# Access Compliance Report

## Public Rights-of-Way

| Intersection ID: 13613                  | Main Street: HAVENWOOD_RD | Cross Street: KILBORNE_DR               | Location: NE           |
| ADA ID: CB7922B1BB15                    | Ramp Type: Perp           | Initial Pass/Fail: Fail                 | Overall Compliance: No |

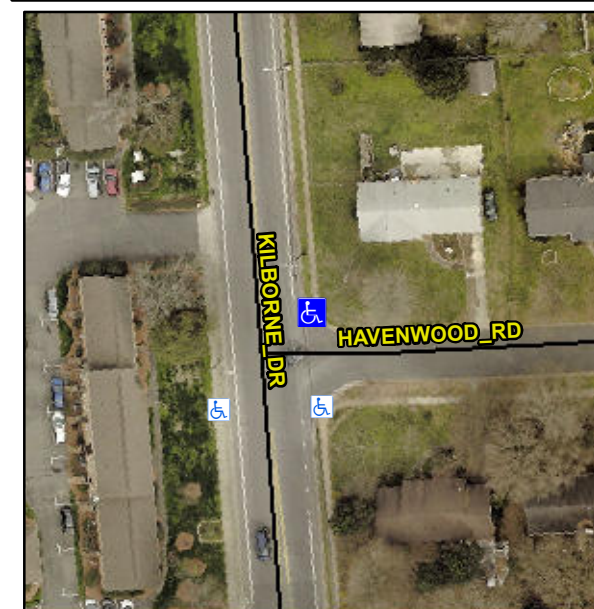
**Not Found, R304.2.2, R304.5.3**

| Compliance | Description           | Data | Compliance | Description                 | Data |
|------------|-----------------------|------|------------|-----------------------------|------|
| N/A        | Ramp Length (in)      | 21.0 | No         | Ramp Slope (%)              | 9.7  |
| Yes        | Ramp Width (in)       | 52.0 | No         | Ramp XSlope (%)             | 4.7  |

**Remove & Replace Entire Ramp.**
